RFT 26-031 Milton # 13 Elementary School and Child Care Facility

PROJECT NO. 22124
HOSSACK & ASSOCIATES ARCHITECTS

ADDENDUM NO. 3

Issued February 24, 2026

FIRE PROTECTION

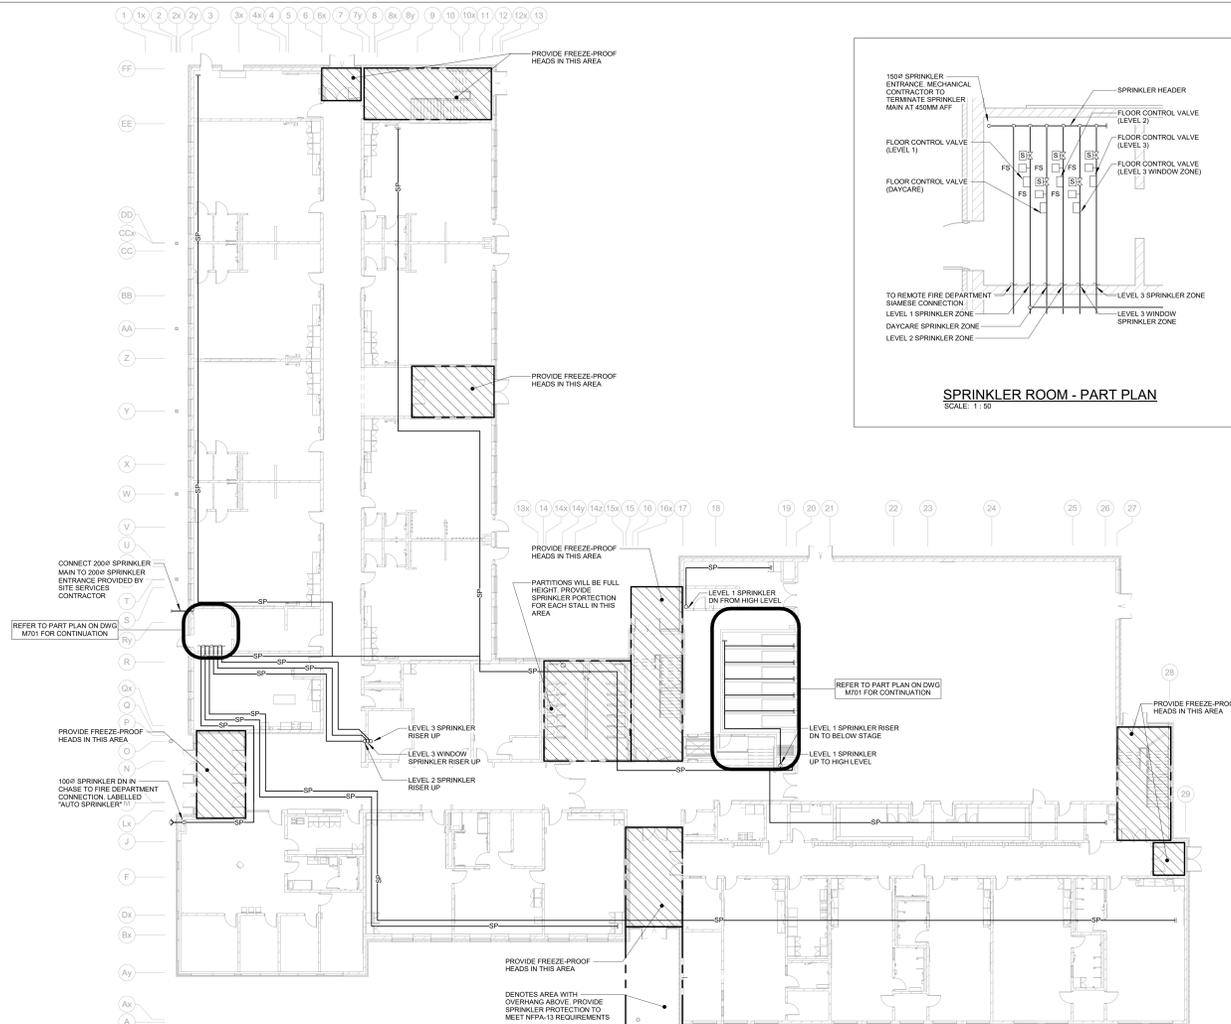
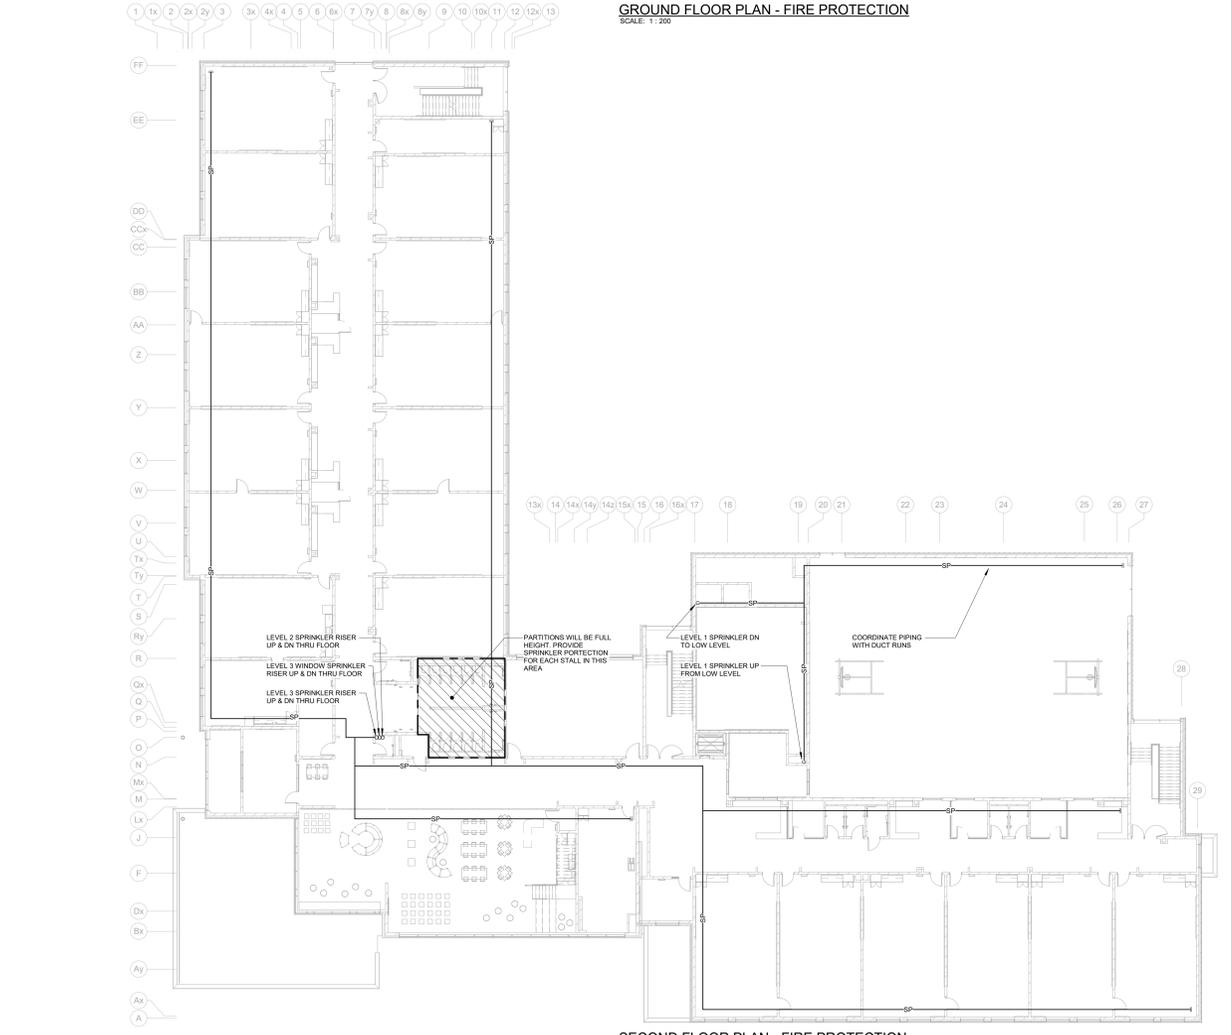
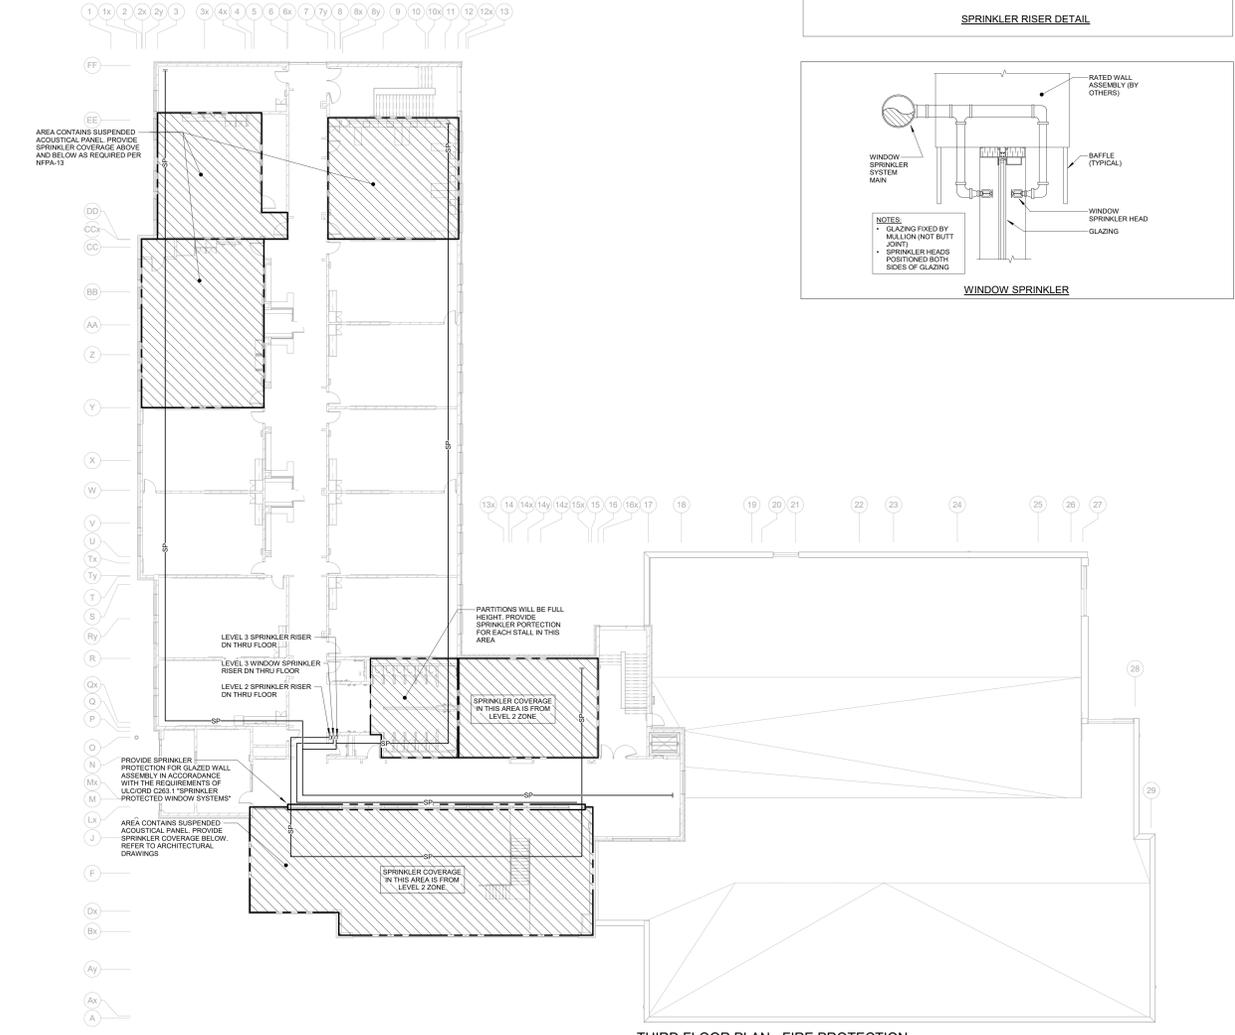
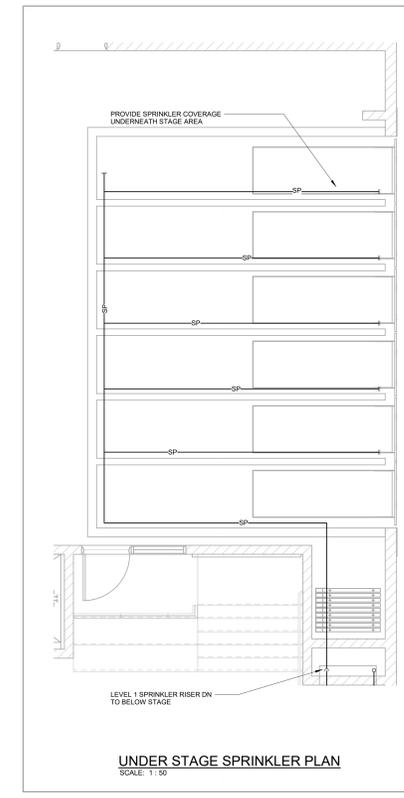
- 2.0 Reference Attached Issued Drawing M701
.1 Add drawing M701 in its entirety.
